# Technical News Bulletin

Steinhausen, September 2012

## Emhart Glass Releases A New Stepper Motor Drive, Replacement Kit. # 27533A For Veritas iB

Veritas iB Stepper Motor Control Panel

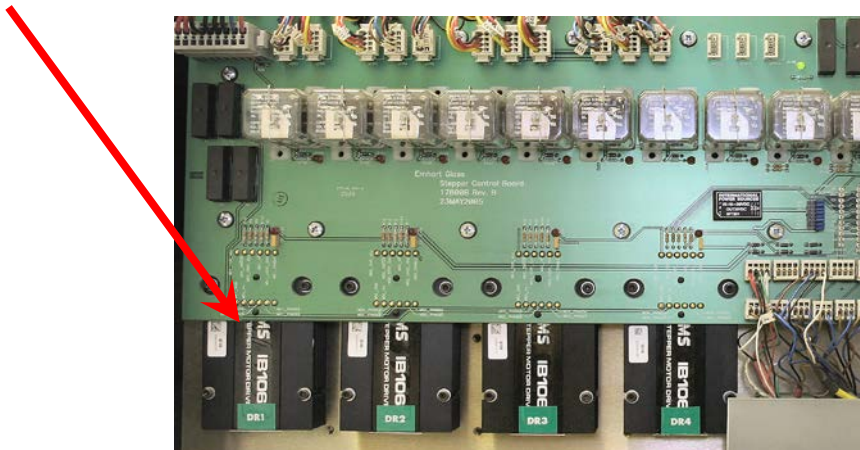
- IB106 Stepper Driver (12706P) for the Veritas iB belt handler will be replaced with update kit # 27533A.
- Installation designed to be simple.
- Detailed mounting instructions included with each kit.

Due to part obsolescence, the IB106 Stepper Driver (12706P) for the Veritas iB belt handler will no longer be available and will be replaced with update kit # 27533A when needed.

Installation of the parts in the new kit was designed to be simple and does not require Emhart Glass service personnel to do the installation. To install, the adapter plate mounts directly to existing holes in the back panel and the pins on the printed circuit board plug directly into the 17800 stepper control board. Detailed mounting instructions for installation of the new replacement parts will be included in each kit.

## Stepper Motor Replacement Kit #27533A Includes:

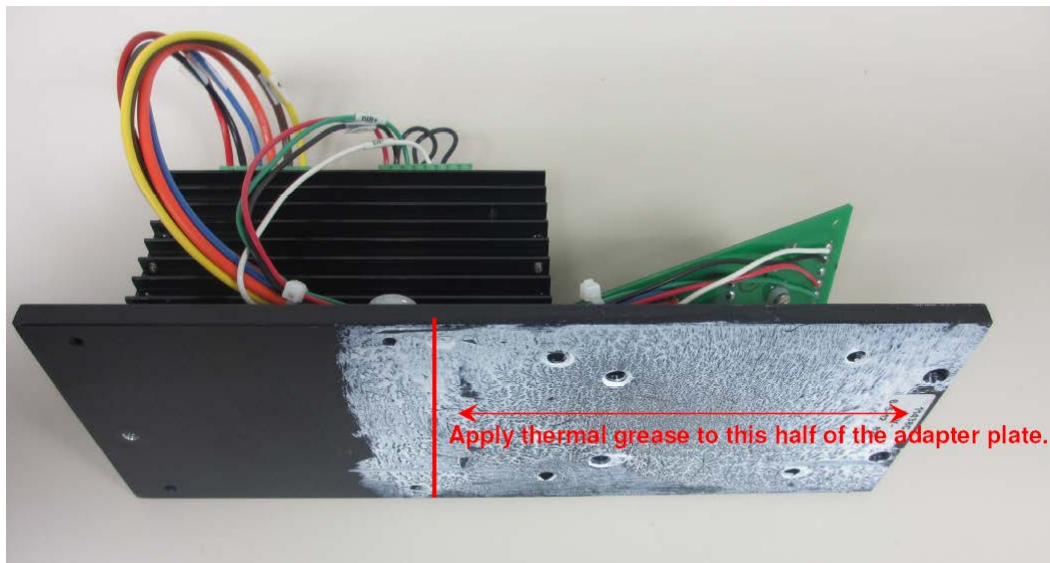
- Qty. 1 - Configured Stepper Drive Part # 21817B
- Qty. 1 - Adapter cable and PCB
- Qty. 1 - Adapter Plate
- Qty. 1 pack - Thermal Grease
